Historic Preservation Design Review

February 25, 2010

HP-10-05, 33-A S. Sumter St. (City)

Shown Above (left) existing front façade wall – only proposed change is the addition of a cloth awning over the entrance; (right) multiple proposed changes to side façade wall include brick patching, replacement of entry door, and painting of wall.

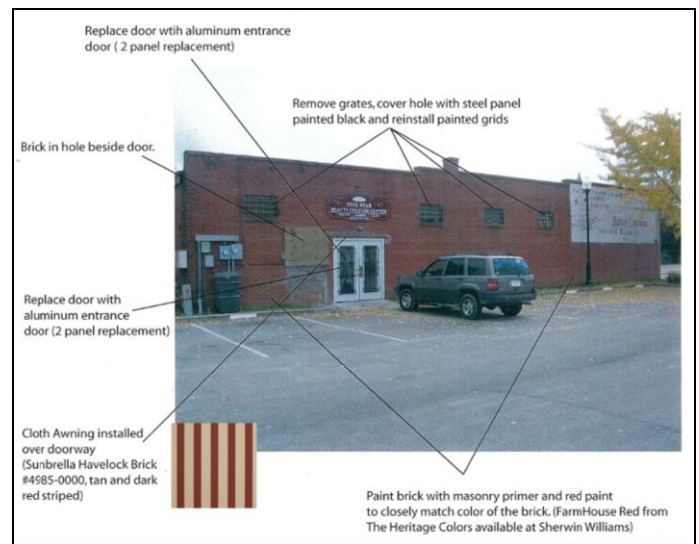
The proposed awnings will be located over the front and side entry doors. The awnings will be a traditional shed style and will have a striped Sunbrella Cover as shown in the graphics on page 2 of this report.

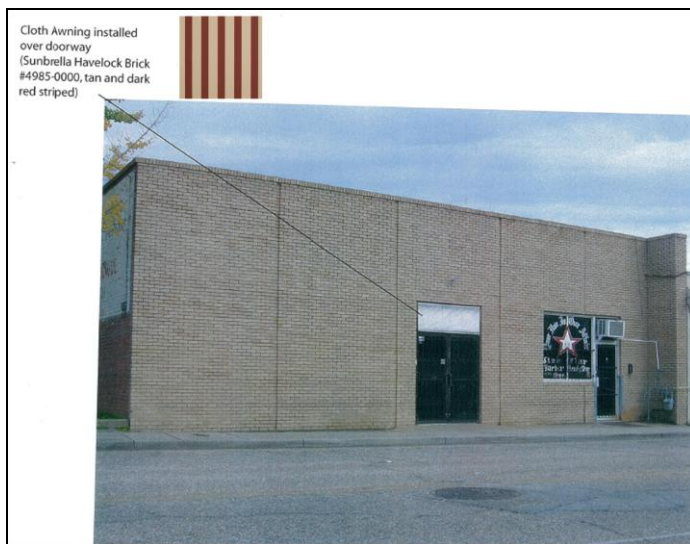
The applicant has proposed to paint the side of the building in a farmhouse red. Although the structure has not been previously painted, due to the extensive patch work that has already been done and the additional brick patch work proposed, painting the side of the building in a color that closely matches the existing brick tone is recommended and requested.

The applicant has proposed to paint the wall of the building as seen in the photo above there is an existing painted sign on the side of the structure.

This sign is an historic wall sign and should be preserved.

- The existing painted wall sign on the side façade be preserved in accordance with guideline #24.

The Sumter Historic Preservation Design Review Committee at its meeting on Thursday, February 25, 2010, voted to approve this request, in accordance with the materials, photographs, and details submitted and referenced in the Staff Report and to paint over the existing wall sign.
